ADDENDUM NUMBER: ONE

**ISSUED BY: SEPW Architecture Inc.
109 - 3725 Pasqua Street, Regina, SK S4S 6W8
PH. (306) 569-2255**

**PROJECT: AIRPORT HANGAR RENOVATIONS
PRINCE ALBERT, SK**

**PLAN SHOWING
TOPOGRAPHY ON
PART OF LOT 2, BLOCK 103,
REG'D PLAN NO. 78PA07887
RCMP HANGAR
PRINCE ALBERT AIRPORT
SASKATCHEWAN
BY T.R. WEBB, S.L.S.
SCALE 1:200**

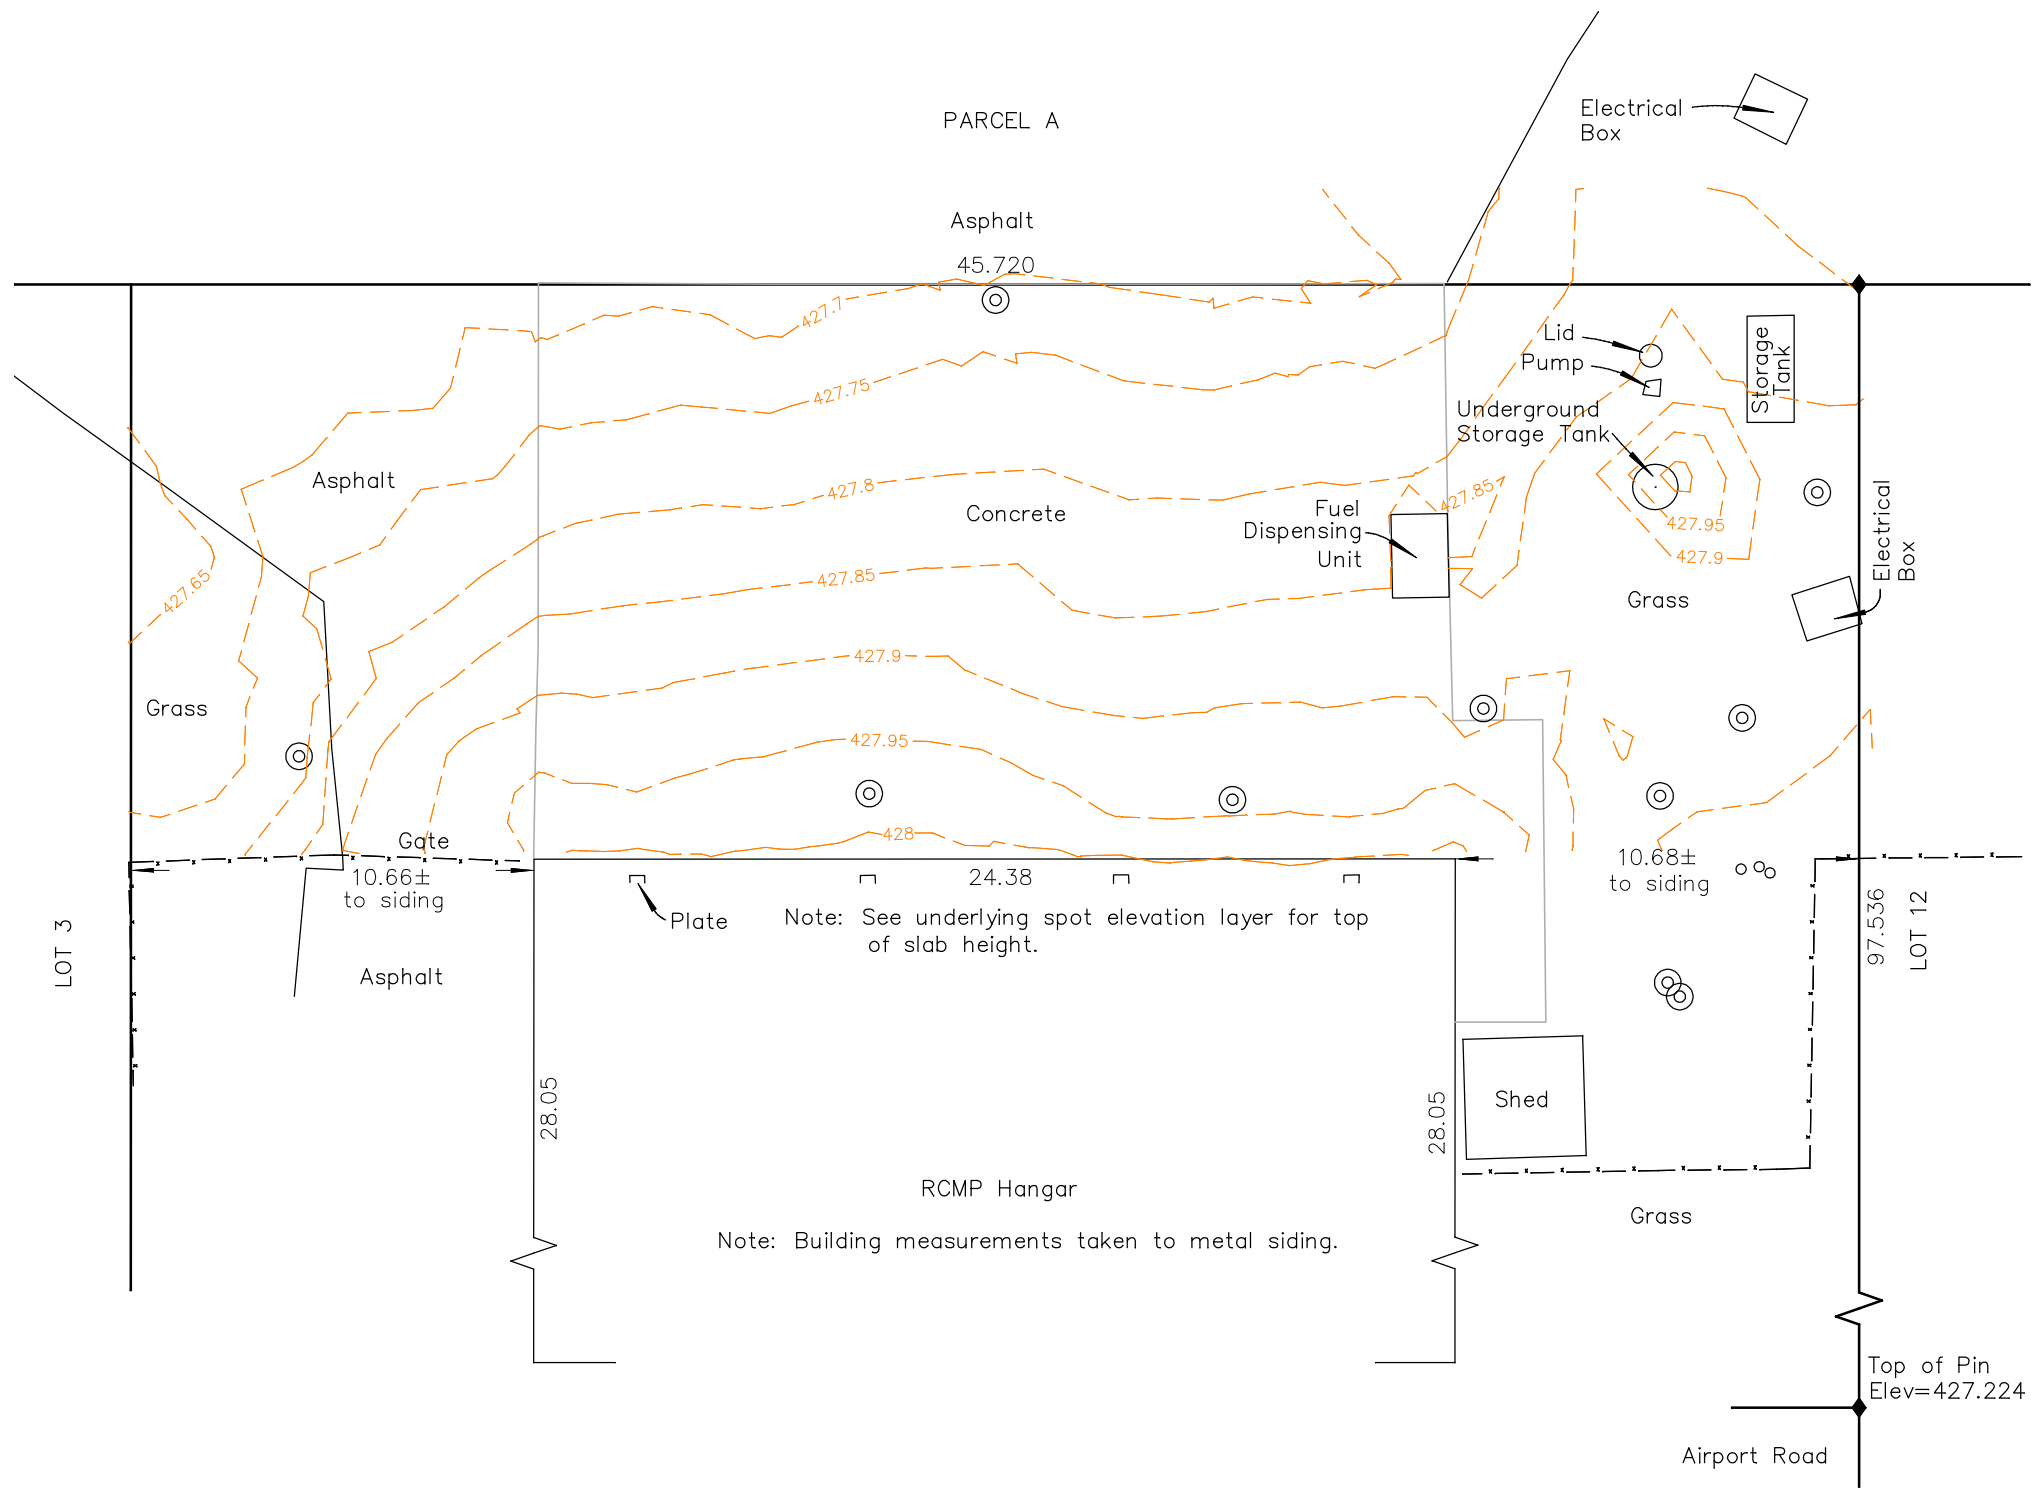
.1 Reference Detail 1, Site Plan; PROVIDE a positive slope away from the building with the new concrete slabs, commencing at the outside of the bottom rails and extending north to the connection of the new and existing concrete apron. Finalized elevations to be provided by Supplemental Instruction. For information purposes, refer to Drawing 16-3004, prepared by Webb Surveys, accompanying this addendum for existing topographical information.

11 PLAN DETAIL
A2.2 1:10

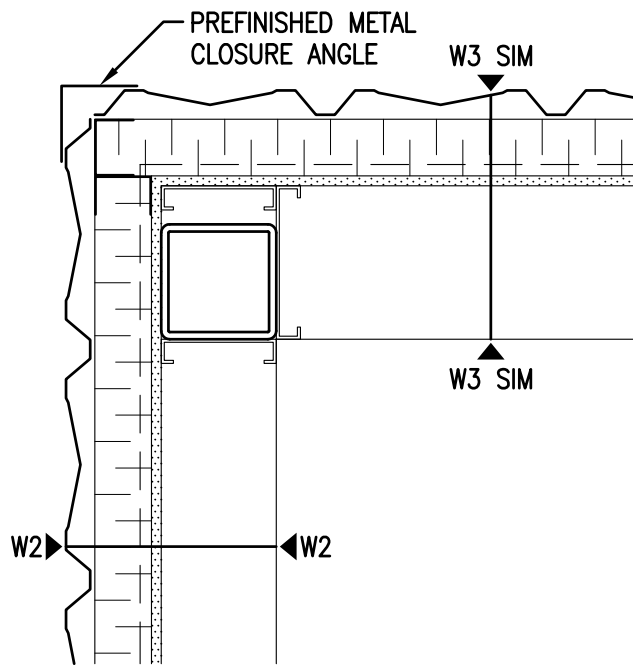
- .1 Reference Detail 11, Plan Detail; REPLACE this detail in its entirety with sketch AR01 accompanying this addendum.

- A: Liner panels are only to act as the vapour barrier when installed on the hangar doors.
- .15 Q: Detail 1/A2.2 & detail 4/A2.2 indicate no cladding inside the column (calling it W2 wall), and detail 2/A6.2 & detail 11/A2.2 indicated cladding inside the column. It doesn't really make sense to put cladding here because there is no part of it that is exposed. Please advise and let us know which drawing detail we need to follow for these walls.

- A: Liner panels are not required for the northwest building enclosure. Refer to sketch AR01 accompanying this addendum.
